## MEMORANDUM

**SUBJECT:** Public hearing and consideration of an application for a Landmark Alteration Certificate to construct an addition to the building, replace non-historic windows and restore the historic façade of Whittier School at 2008 Pine Street, an individually landmarked property, per section 9-11-18 of the Boulder Revised Code 1981 (HIS2015-00243).

1. Site: 2008 Pine St.
2. Designation: Individual Landmark
3. Historic Name(s): Pine Street School, Whittier School
4. Date of Construction: 1882
5. Zoning: RMX-1 (Residential-Mixed 1)
6. Lot size: 103,693 sq. ft.
7. Proposed Addition: 1,056 sq. ft.
8. Applicant: Rodwin Architecture
9. Owner: Boulder Valley School District

Figure 5. Site Plan. Location of north entry proposal outlined in red.

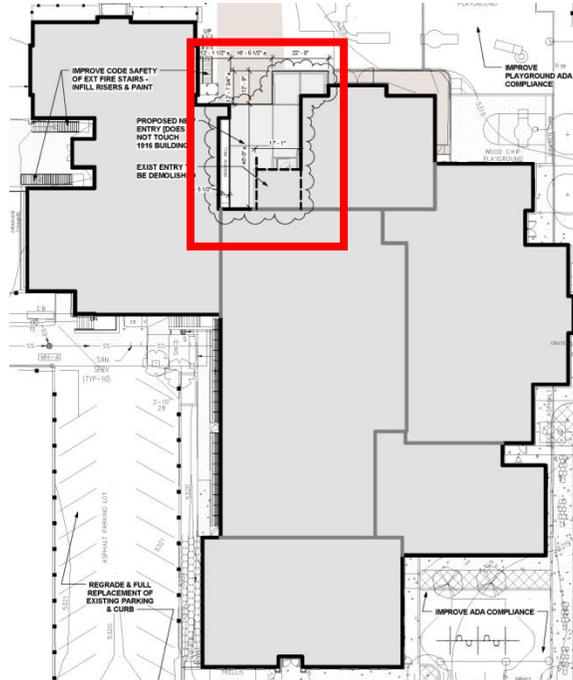
The proposed north entry will not be attached to the 1916 portion of the building with the exception of a wall of a small mechanical stair bump-out. A window well will separate the rest of the 1916 building from the proposed entry. This is intended to minimize impact on the historic portion of the school.

In concept, the design of the north entry is a glass cubic form intended to provide an open view to the east wall of the historic 1916 portion of the school. In plan the north wall of the new construction is shown to be set back between 18' & 32' feet from the façade of the 1882 school building. The current non-historic entry proposed for removal is located approximately 56' back from the 1882 façade.

Staff considers the proposed removal of the c. 1980 entryway and construction of a new glass entryway that is more transparent to be generally consistent with the design guidelines. Care will need to be taken to detail the addition in a way that references and is compatible with the historic building. Staff suggests subtle

integration of the form and proportion of the glass panes found on the historic school might be a way to achieve better compatibility.

Figure 9: Proposed north entry detail.

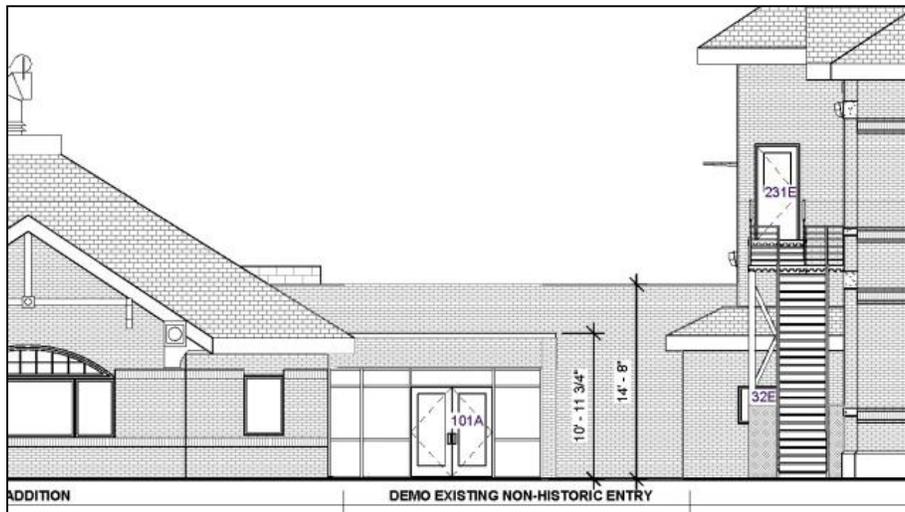
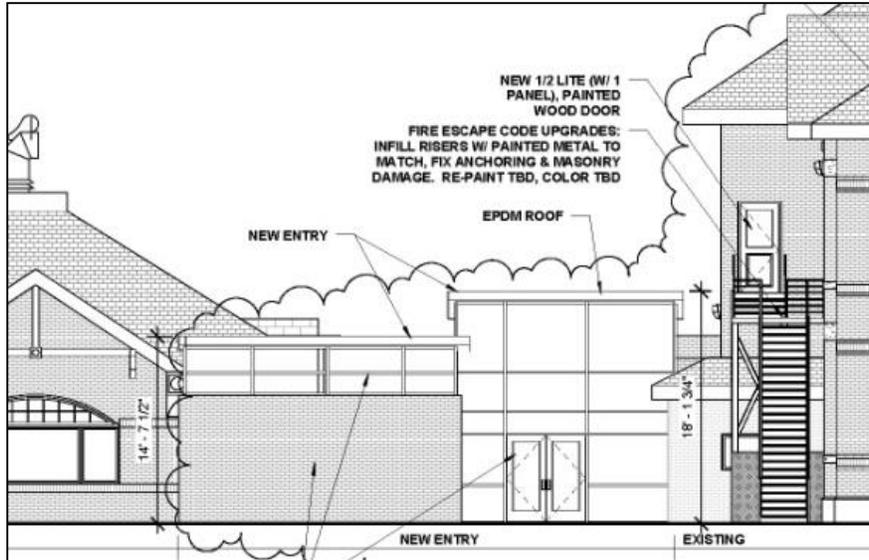
.6	<i>Use window shapes that are found on the historic building. Do not introduce odd-shaped windows such as octagonal, triangular, or diamond-shaped</i>	Transparency provides compatibility. Review of proportions of glass segments might be designed in way to reference proportions found on historic portion of school. Review at Ldrc	Maybe
.7	<i>Do not add divided light windows to structures that historically did not have divided light windows.</i>	See .6 and .7 above	Maybe
.8	<i>Use materials and construction similar to historic windows. Do not use snap-in mullions.</i>	See .6 and .7 above. Staff considers metal and glass to be compatible given type of building and nature of transparent form to which the addition aspires.	Maybe

Figure 13. Detail of existing (l) and proposed (r) west entry doors on 1916 addition

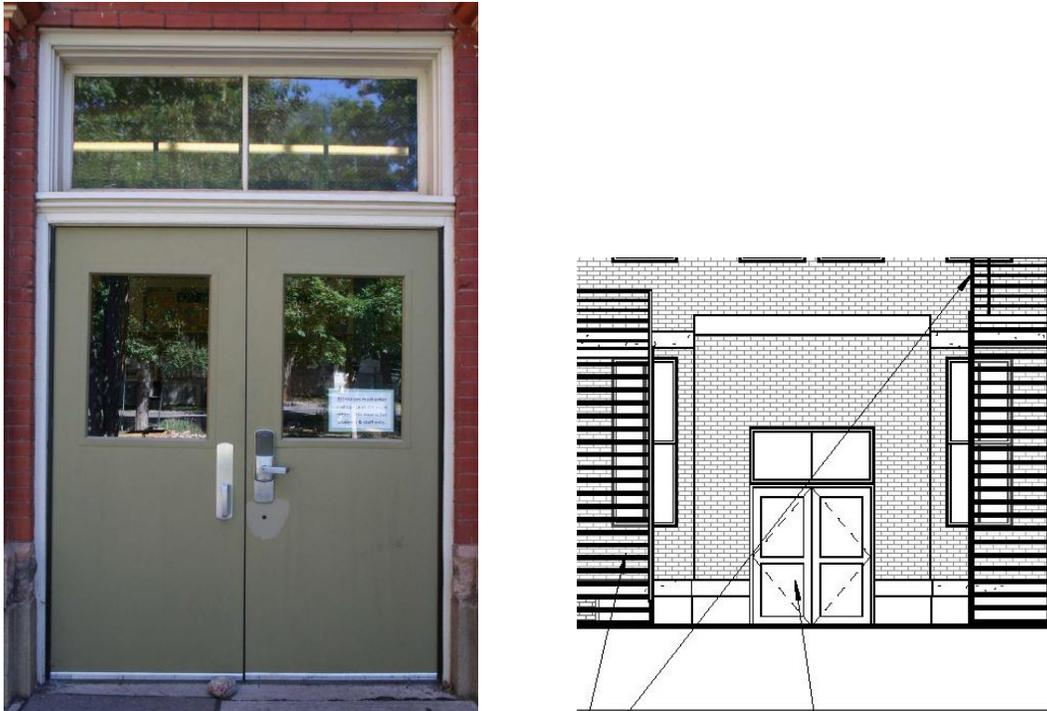
The non-historic doors of the original 1882 building and the 1916 addition are shown to be replaced with energy efficient doors that closely replicate the historic doors shown in historic photographs. A door and window assessment submitted with the application shows the non-historic doors having being installed in either 1997 or 1998. The other non-original openings in the 1916 building, which are currently metal, will be replaced with painted wood doors with a clear glass half-lite.

<b>3.8 Doors and Storm Doors</b>			
	<b>Guideline</b>	<b>Analysis</b>	<b>Meets Guideline?</b>
.1	<p><i>Whenever possible, retain and preserve all original doors and door openings. The location of the door(s) proposed for retrofit or replacement is important in assessing their significance to a historic building. In general, the more important the elevation, the less likely that replacement of a historic door will be appropriate. Elevations will be categorized as primary, secondary, or tertiary, using the methodology set out in the Window &amp; Door Replacement Application and Survey.</i></p>	<p>Front doors on 1882 school are c.1990s non historic replacements – proposal is to restore historic doors based upon historic photographs. Doors which were original windows providing access to exterior stairs are also non-historic replacement. Proposal calls for replacement with simple half-light doors, more in character with the historic buildings. Details of exterior stairs proposed for replacement and new doors should be reviewed by the Ldrc.</p>	<b>Yes</b>

The proposal to rehabilitate historic windows and to replace non-historic windows is the result of a detailed window and door inventory undertaken by the architect. Staff considers the approach to be consistent with Sections 3.7 and 3.8 of the *General Design Guidelines*. Restoration of the historic building including repointing and reconstruction of the front doors based on historic photos will enhance the historic character of the school. Staff considers replacement of and continued use of exterior stairs necessary to the functioning of the school. Details of the windows and door work, masonry restoration and stair replacement should be reviewed by the Landmarks design review committee as a condition of approval.

Figure 18. Proposed west elevation, 2015.

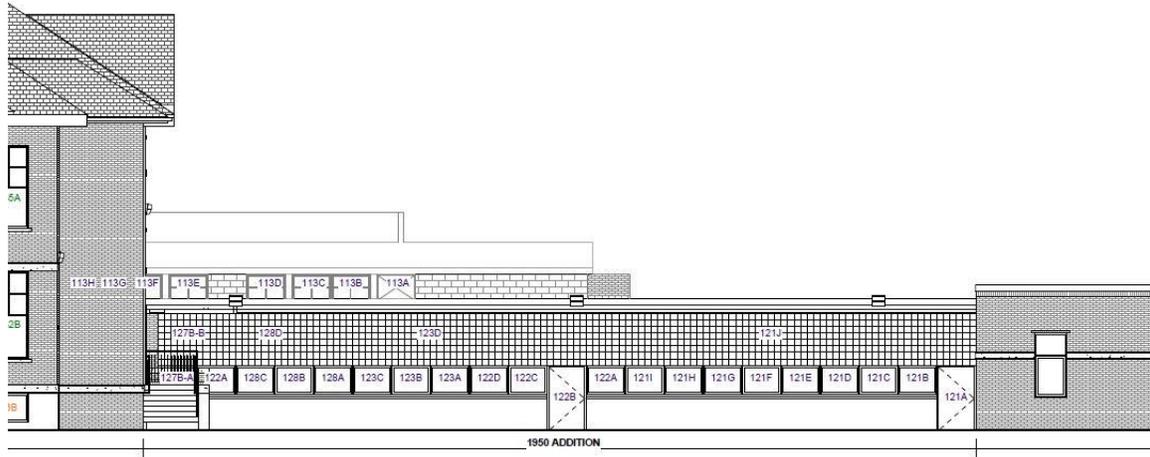
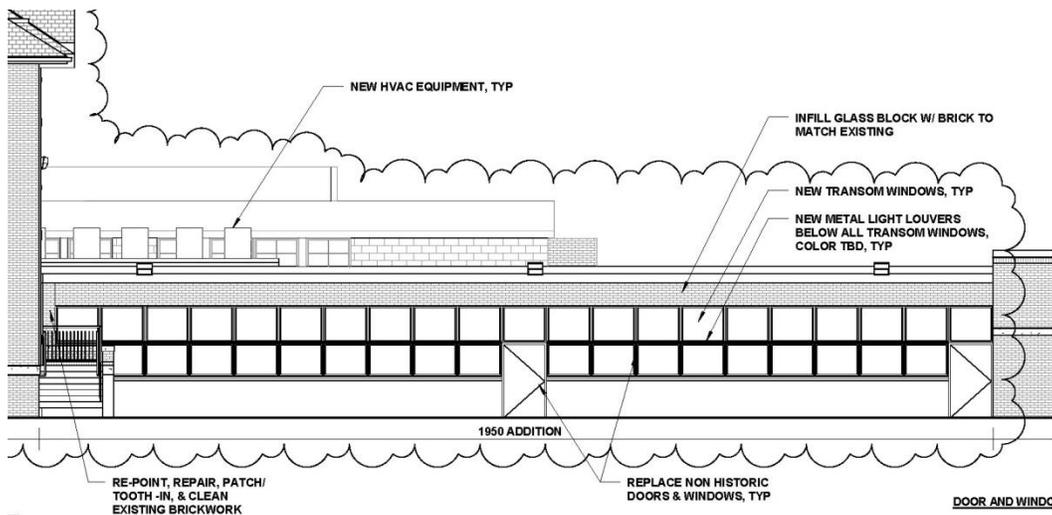
Applicant proposes the replacement of doors & windows on the 1950 addition of Whittier School. This includes the Gym clerestory windows and the infill portion of glass block on the west elevation. The 1950 addition is directly south of the 1916 addition and the 2010 addition abuts the south of the 1950 addition. The request calls for replacement with energy-efficient insulated windows with a metal storefront and will have painted metal light louvers.

<i>may be appropriate to use window elements from rear or side elevations to repair those on the front.</i>	to be historic and new windows are to be installed replacing glass block. Details of window replacement should be reviewed by the Landmarks design review committee.	
.4	<i>In some cases, retrofitting historic windows to make them more energy efficient may be appropriate as part of a building rehabilitation program. Typically a window retrofit preserves most or all of the historic wood, glass, or metal components and consists of insulating weight pockets and complete weather stripping of its sash and frames. If a window retrofit calls for the replacement of single pane glass, it is important to determine that the work will not compromise the historic character of the building or the district in which it is located. Historic glass is typified by its “wavy” uneven surface which can be an important character defining feature of a window and the historic building as a whole. Depending upon its location on the building, the importance to the window itself, and relative condition, the replacement of historic glass may be inappropriate.</i>	Historic windows on the 1882 and 1916 portions of the building will be rehabilitated, weather stripped and fitted with storm window systems. Details of window retrofit should be reviewed by the Landmarks design review committee.

Likewise, staff considers the 1950s portion of the school to not have historic significance and that replacement of the glass block and windows and doors with new windows and doors consistent with the design guidelines provided the details of this work is reviewed by the Landmarks design review committee.
